**Pacific Gas and
Electric Company**

PG&E Letter DCL-01-096

**Docket No. 50-275, OL-DPR-80
Docket No. 50-323, OL-DPR-82
Diablo Canyon Units 1 and 2
License Amendment Request 01-02,
Credit For Soluble Boron In The Spent Fuel Pool Criticality Analysis**

FIGURE 3.7.17-1
MINIMUM REQUIRED ASSEMBLY DISCHARGE BURNUP
AS A FUNCTION OF INITIAL ENRICHMENT (NO IFBA) TO PERMIT
STORAGE IN REGION 1

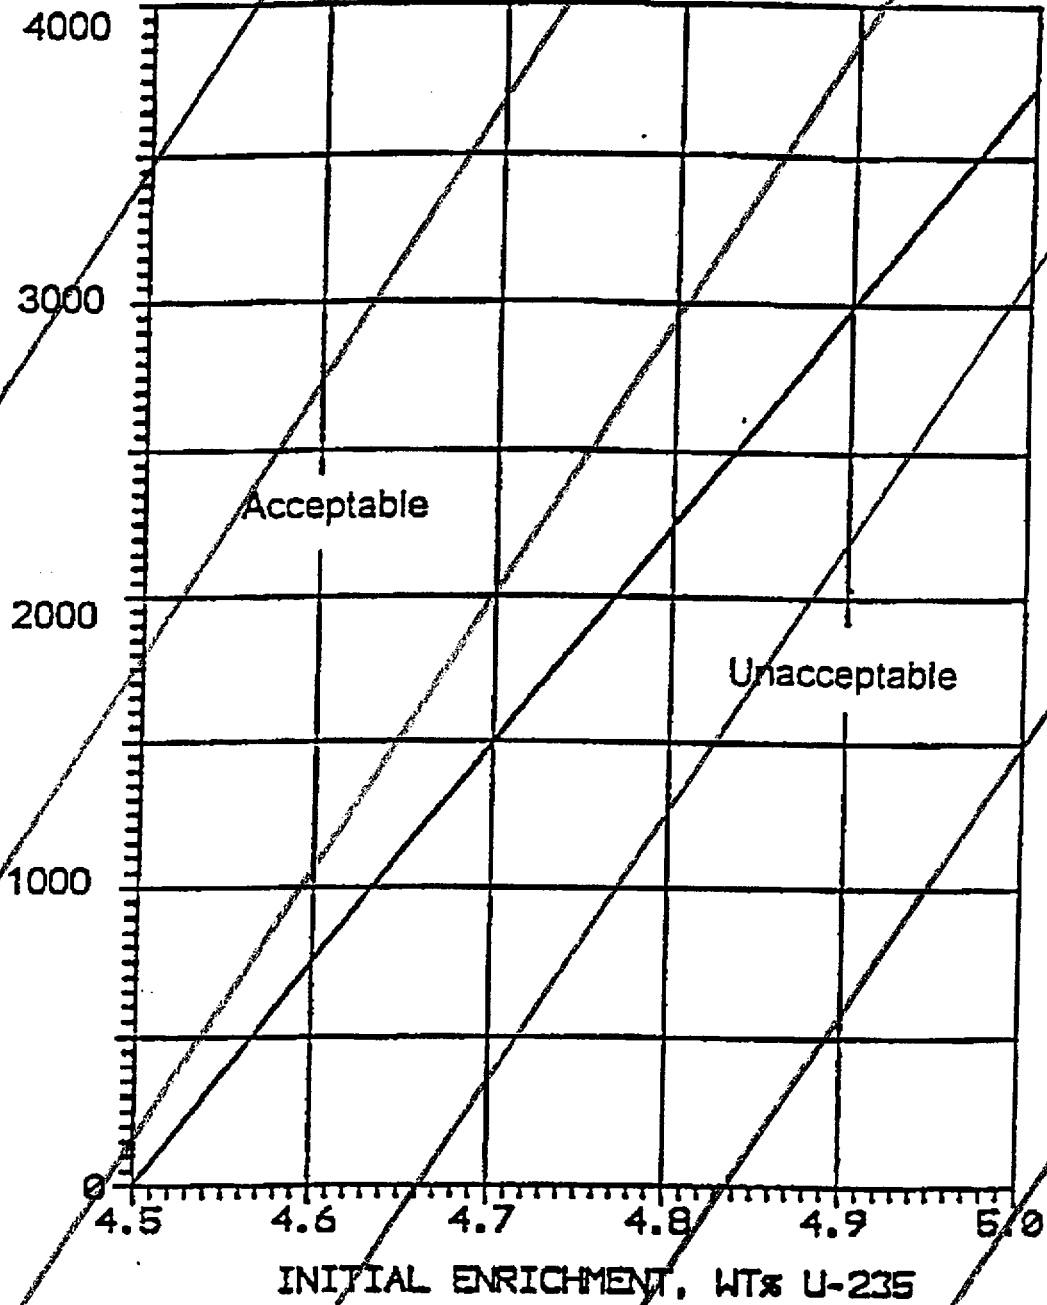
4. Figure 3.7.17-1: This figure would be deleted and replaced by a new figure to provide graphical representation of allowable storage configurations (all cell, 2-by-2 array, and checkerboard) in the SFP.

FIGURE 3.7.17-1
ALLOWABLE STORAGE CONFIGURATIONS
(ALL CELL, 2X2 ARRAY, CHECKERBOARD)
FOR THE SPENT FUEL POOL

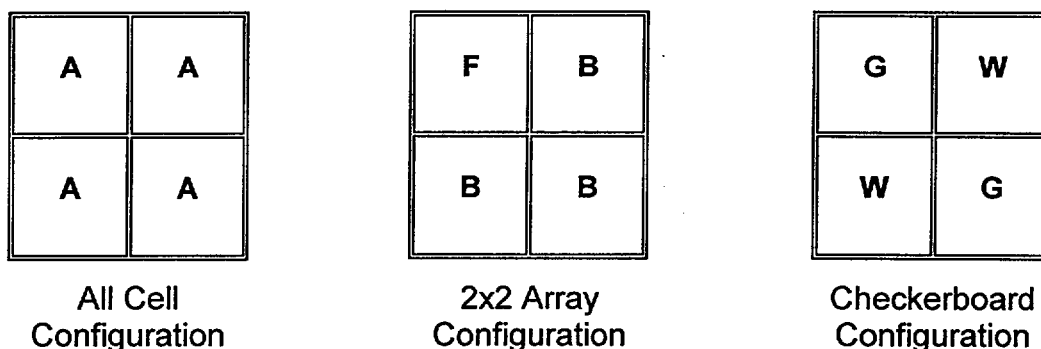
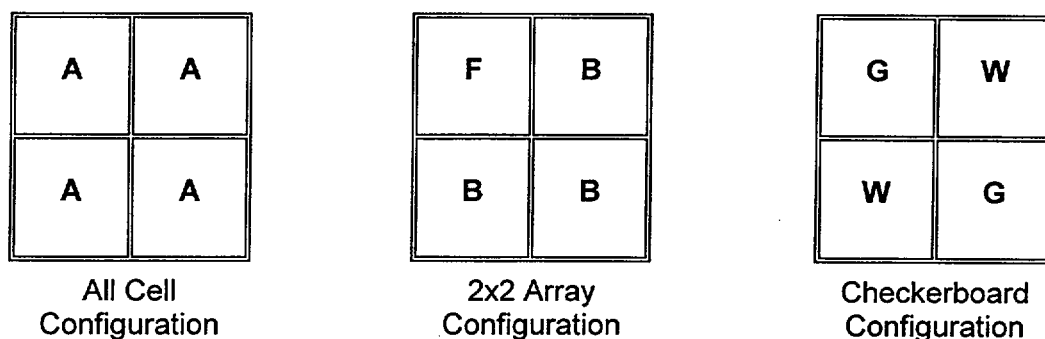
Fuel assembly storage in the spent fuel pool shall be maintained such that any four cells shall be in a configuration as shown in Figure 3.7.17-1.

LCO 3.7.17 Fuel assembly storage in the spent fuel pool shall be maintained such that any four cells shall be in a configuration as shown in Figure 3.7.17-1.

Figure 3.7.17-2
MINIMUM REQUIRED ASSEMBLY DISCHARGE BURNUP
AS A FUNCTION OF INITIAL ENRICHMENT TO PERMIT
STORAGE IN REGION 2

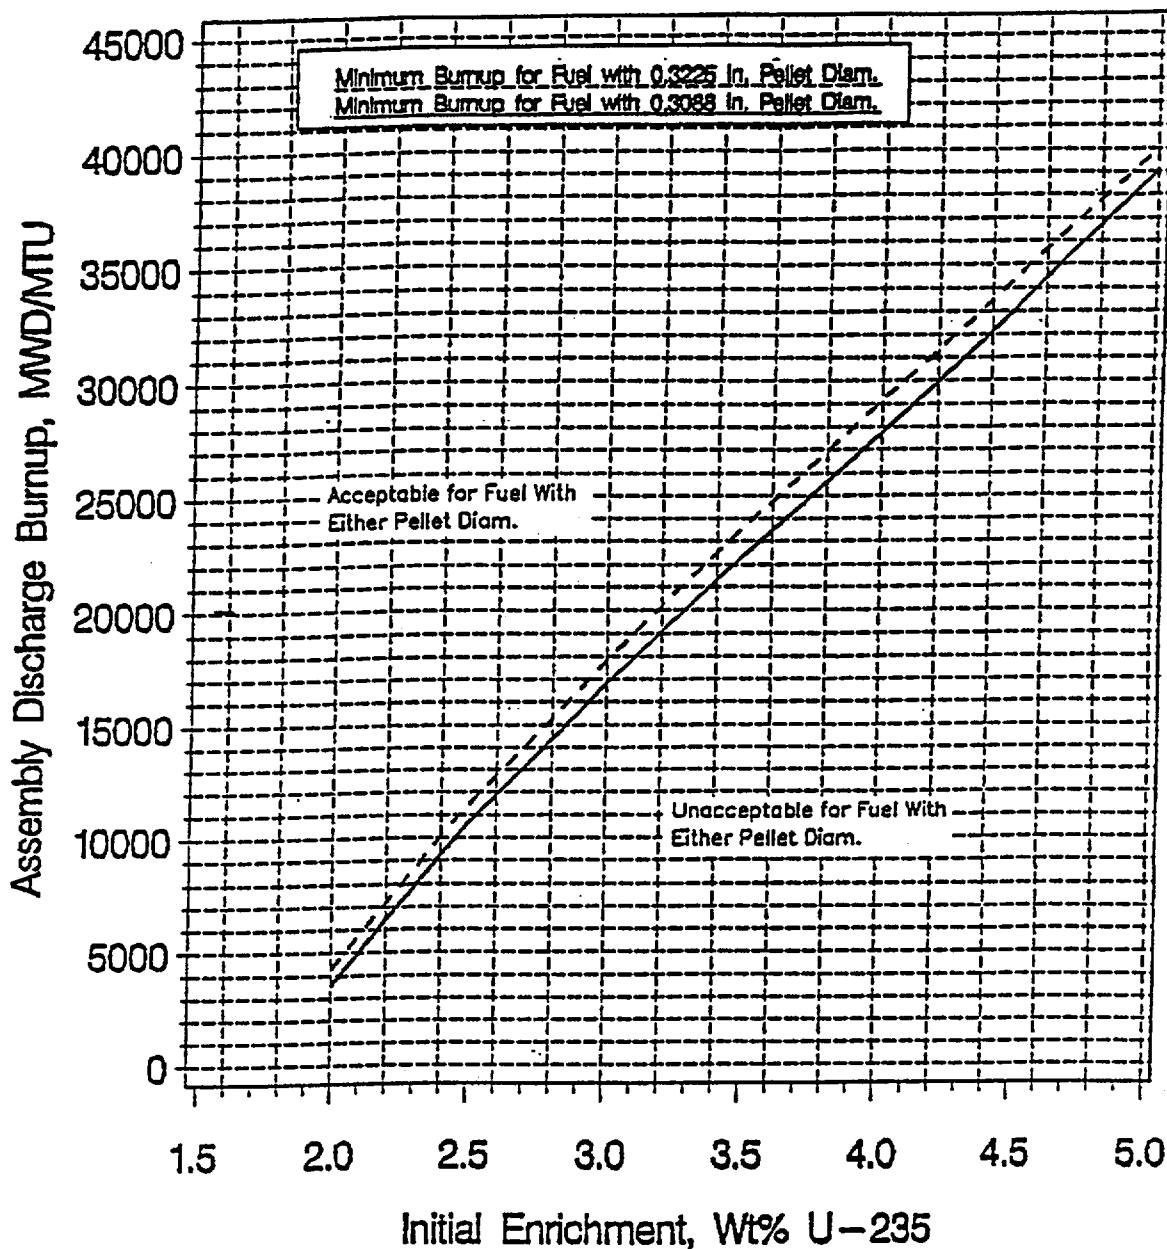
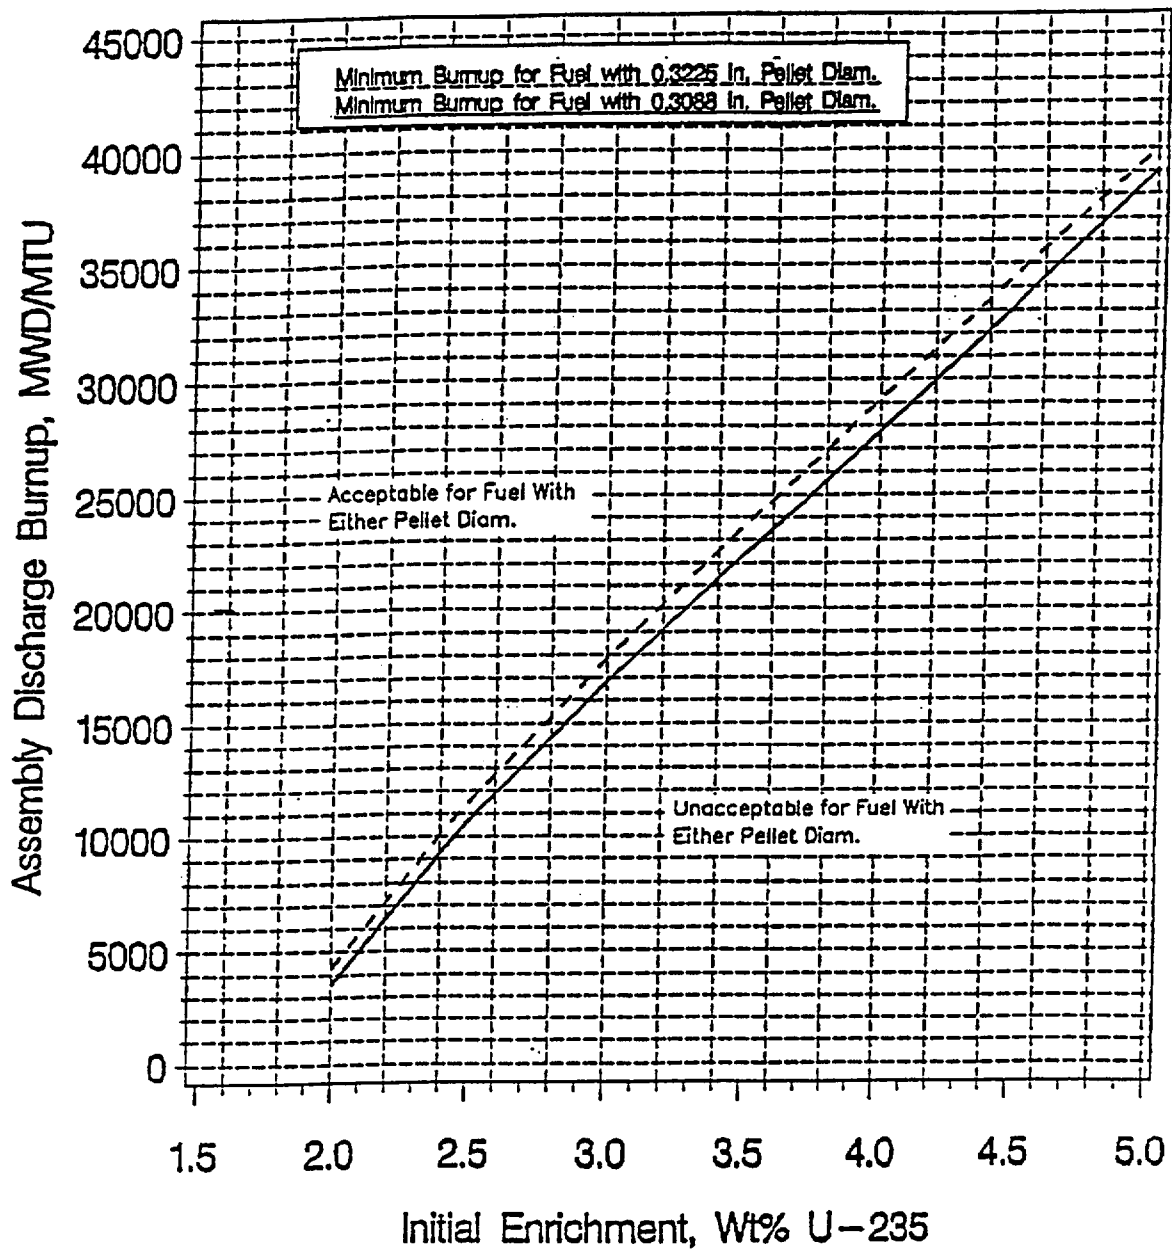
5. Figure 3.7.17-2: To clarify that this figure is a function of fuel pellet diameter and that it provides the acceptable/unacceptable enrichment-burnup requirements for an all cell configuration, the title would be revised to, "Figure 3.7.17-2 Minimum Required Assembly Discharge Burnup as a Function of Initial Enrichment and Fuel Pellet Diameter for an All Cell Storage Configuration."

FIGURE 3.7.17-2
MINIMUM REQUIRED ASSEMBLY DISCHARGE BURNUP
AS A FUNCTION OF INITIAL ENRICHMENT AND FUEL PELLET DIAMETER
FOR AN ALL CELL STORAGE CONFIGURATION

FIGURE 3.7.17-3
MINIMUM REQUIRED ASSEMBLY DISCHARGE BURNUP
AS A FUNCTION OF INITIAL ENRICHMENT
FOR A 2X2 ARRAY STORAGE CONFIGURATION

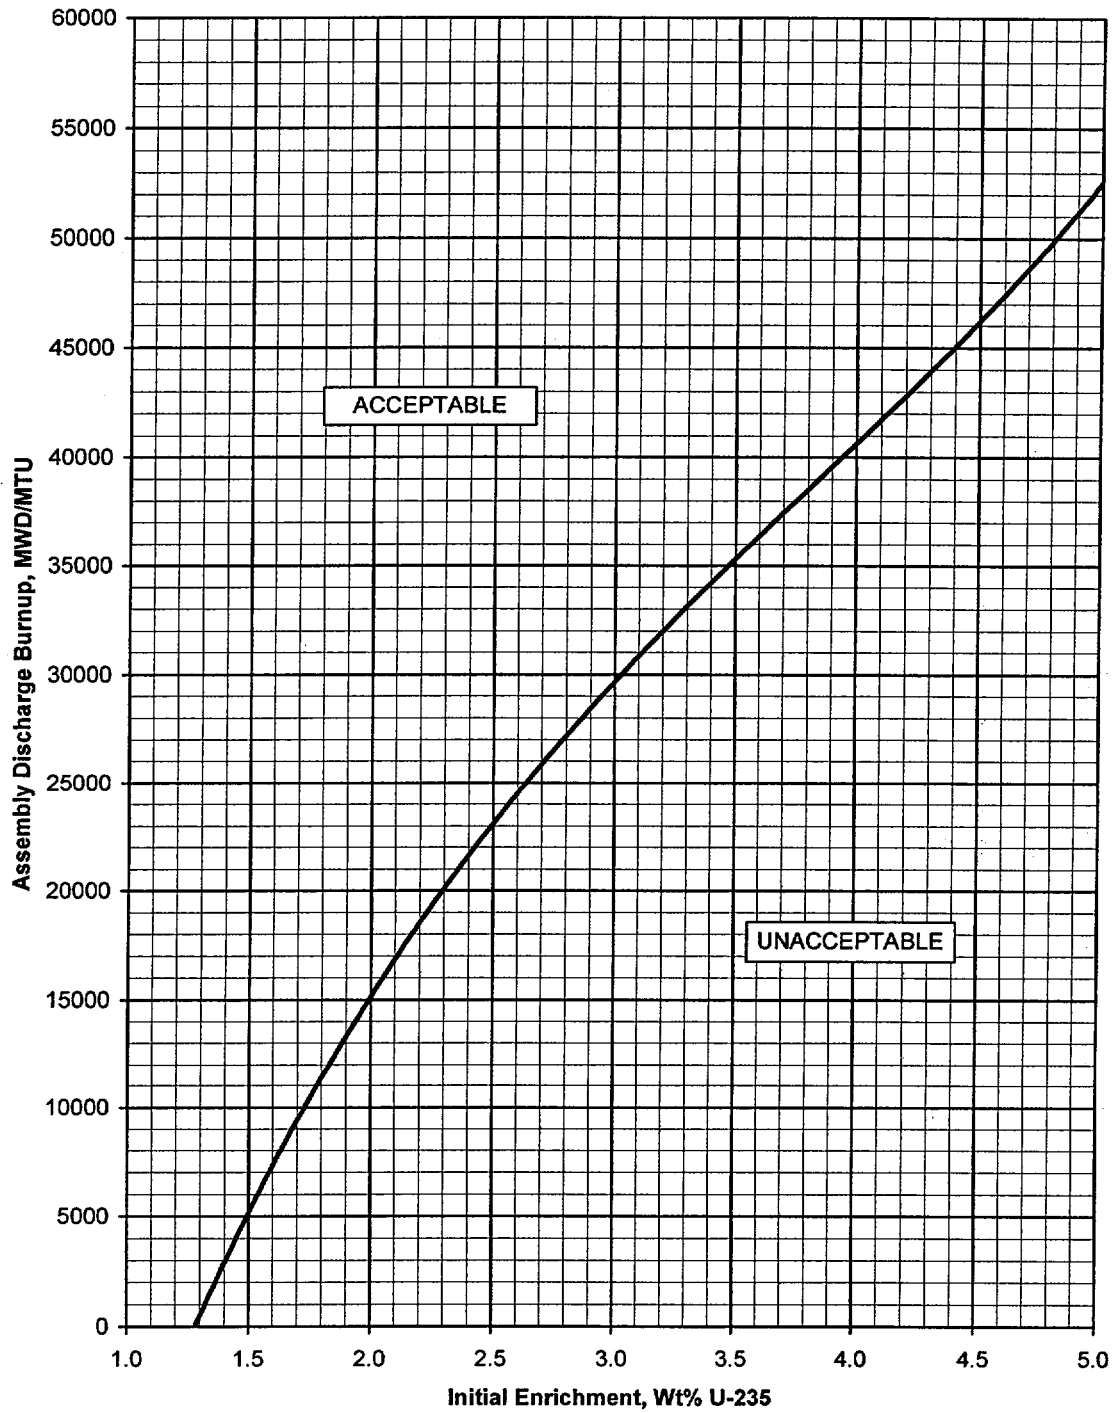
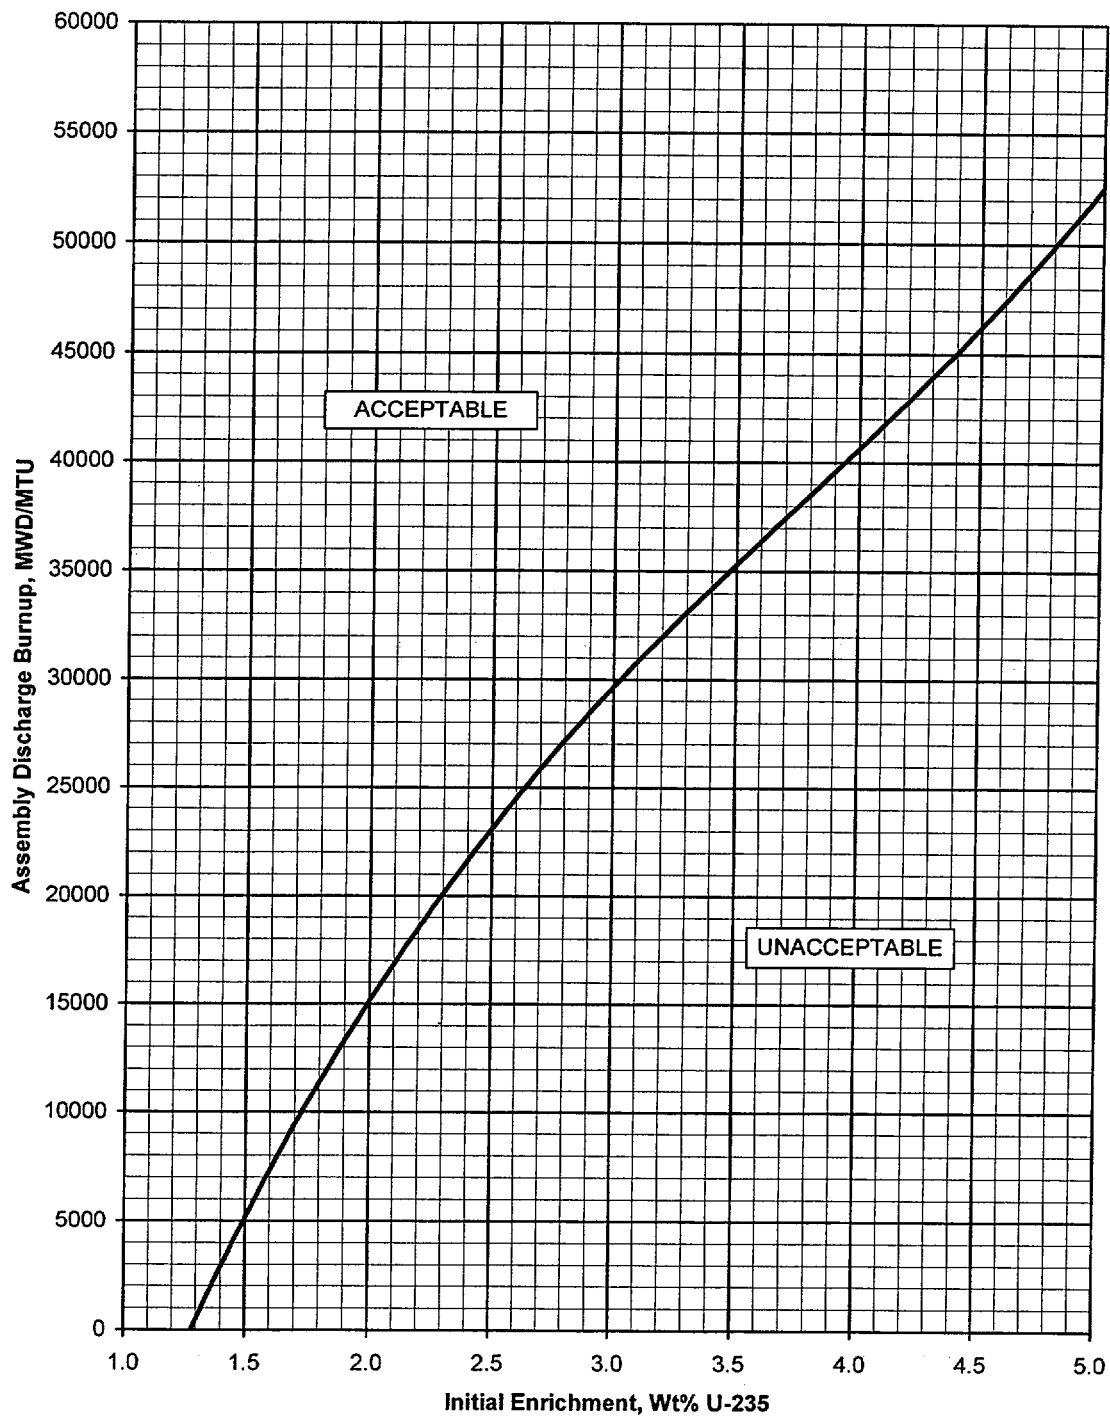
6. Figure 3.7.17-3: This new figure would be added to provide the acceptable/unacceptable enrichment-burnup requirements for the burned fuel assemblies within a 2-by-2 array configuration.

FIGURE 3.7.17-3
MINIMUM REQUIRED ASSEMBLY DISCHARGE BURNUP
AS A FUNCTION OF INITIAL ENRICHMENT
FOR A 2X2 ARRAY STORAGE CONFIGURATION
